Addendum #%
Bid Opportunity: 25-7639-RFT - Alpine Public
School HVAC Upgrade
Closing Date: Monday, March 31, 2025 2:00 PM

ADDENDUM NO. 1

Issued by email March 19, 2025

WRDSB ALPINE PS HVAC UPGRADE

Item 07: Drawing A05 DEMOLITION AND PROPOSED RCP PLAN – SECTION B

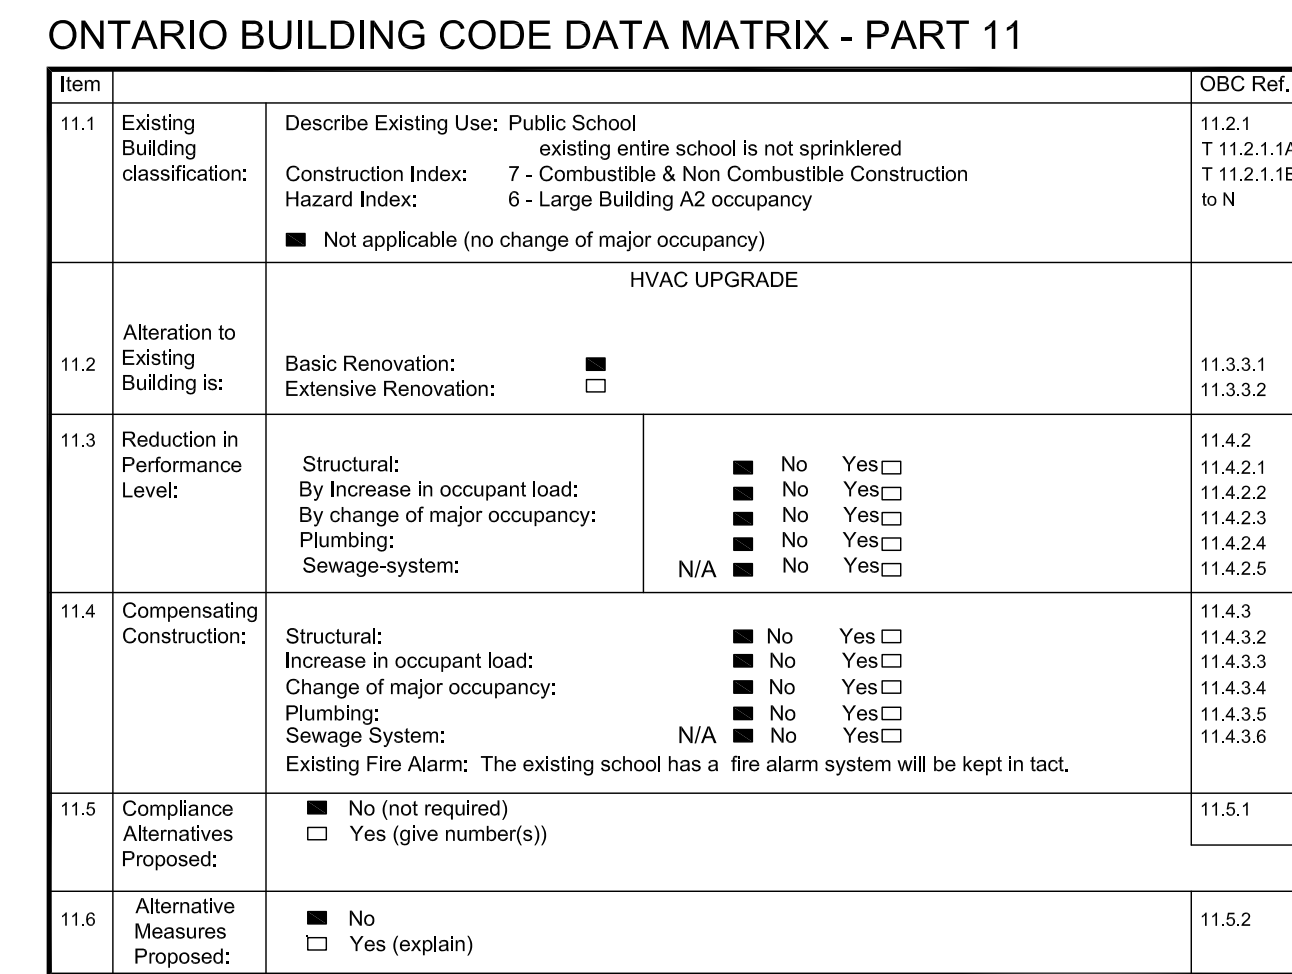
- .1 REVISE Room name of “Trans X049” to “Storage Room X049”.
